HITACHI SEMICONDUCTOR TECHNICAL UPDATE

Classification of Production	Micro-controller			No	TN-SH7-397A/E	
THEME	Revision of the incorrect information in the SH7144 Hardware Manual and information on the use of the I ² C bus interface	Classification of Information	1. Spec change ② Supplement of Documents 3. Limitation of Use	4. Change of Mask	5. Change of Production Line	
PRODUCT NAME	SH7144 series	Lot No.	Reference Documents	SH7144 Series Hardware Manual	Rev.	Effective Date
		ALL			1.0	Permanent

Incorrect information in the SH7144 Hardware Manual has been revised. In addition, the limitation on use of the I²C bus interface is now described.

Figure 1 Scheme of Slave Transmit Operation

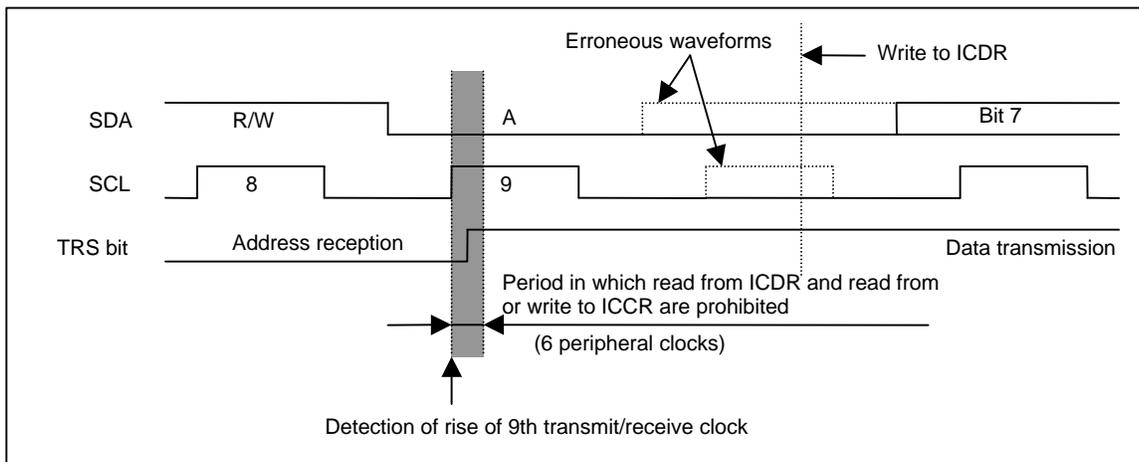
(1) In slave transmit operation of the I²C bus interface module, when ICDR is read from or ICCR is read from or written to at the moment address reception is switched to data transmission, erroneous data may be transmitted.

In normal transmit operation, when a first frame is received and the received address matches, the TRS bit is automatically set to 1 and transmit mode is entered if the R/W bit of the 8th clock cycle is 1. The SCL pin is then fixed to low from the fall of the 9th clock of the first frame until the transmit data is written to the ICDR register.

However, when ICDR is read from or ICCR is read from or written to within 6 peripheral clock cycles (half-tone dot-meshing area in figure 1) after the rising edge of the 9th transmit/receive clock for address reception of the first frame, the SCL pin is not fixed low after the fall of the 9th clock for the first frame. The master device starts sending clock signals before the slave device has written transmit data to ICDR. As a result, data in the ICDR shift register is output to the SDA pin, and erroneous data is transmitted to the master device.

In slave transmit operation, do not read from ICDR or read from or write to ICCR during the period indicated by half-tone dot-meshing in figure 1.

For the interrupt processing that normally occurs in synchronization with the rising edge of the 9th transmit/receive clock, reading from ICDR or reading from or writing to ICCR causes no problems because the prohibited period ends before transiting to the interrupt processing.

To ensure that this interrupt processing is carried out, satisfy either of the following conditions.

- i) Before the next slave address reception starts, complete the ICDR read operation and ICCR read/write operation.
- ii) Monitor the BC2 to BC0 bits (bit counters 2 to 0) in ICMR, and when the BC2 to BC0 bits are all cleared to 0 (8th or 9th clock), wait for at least two transmit/receive clocks before reading from ICDR or reading from or writing to ICCR to avoid the period in which these operations will cause a failure.

Figure 2 Scheme of TRS Bit Setting in Slave Mode

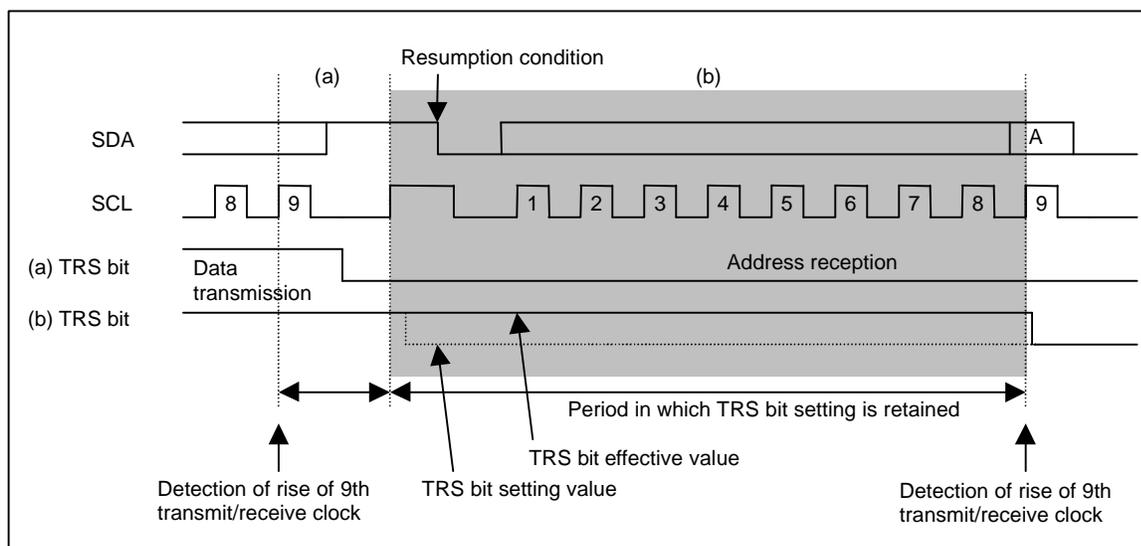
In slave mode, the TRS bit setting in ICCR becomes valid as soon as the bit is set during the period from when the rising edge of the 9th clock or a stop condition is detected to the next rising edge at the SCL pin (period (a) in figure 2).

However, for any other period (i.e., period (b) in figure 2), the TRS bit setting is retained until the next rising edge of the 9th clock or a stop condition is detected, so that the TRS bit setting does not become valid immediately.

Accordingly, in the address reception following input of a resumption condition, the internally effective TRS bit setting remains 1 (transmit mode), and the acknowledge bit that should be transmitted at the end of address reception is not transmitted at the 9th transmit/receive clock.

(2) To change, without transiting to the stop condition, from slave transmit operation (TRS = 1) to next address receive operation (TRS= 0) by the input of resumption condition, clear TRS to 0 during time period (a) in figure 2, when the I2C bus interface in the SH7144 series is in slave mode.
